LAND CRUISER (100 series)

OUTLINE OF NEW FEATURES

The following changes are made for the new Land Cruiser (100 series).

STD and GX Grade

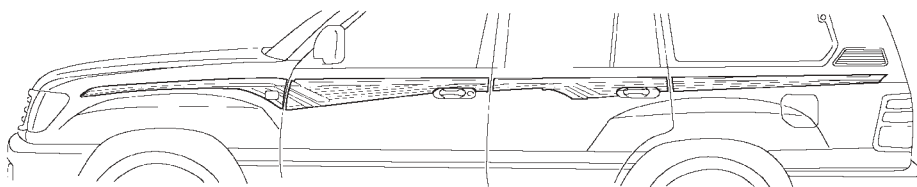
The design of the side stripes, provided as an option on all models, have been changed.

6. Brake Control System (ABS with EBD, Brake Assist, A-TRC and VSC System)

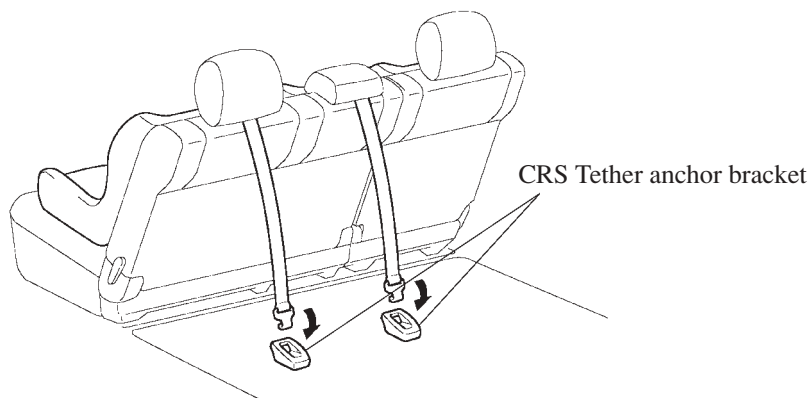
- The brake control system (ABS with EBD, Brake Assist, A-TRC and VSC system) has been added to the models equipped with the 1HD-FTE engine and 5-speed automatic transmission for Australia and Europe, as optional equipment.

It is available as a set with the VGRS (Variable Gear Ratio Steering) system on the models equipped with the 1HD-FTE engine and 5-speed automatic transmission for Europe.

- Along with the changes made to the skid control ECU, the diagnosis detection performance has been improved.

8. Wind Washer System

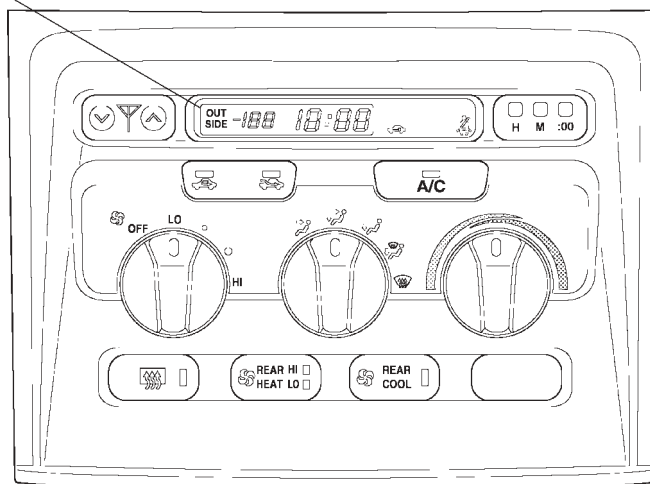
The inlet of the washer tank has been widened in order to shorten the length of time it takes to fill the washer tank.
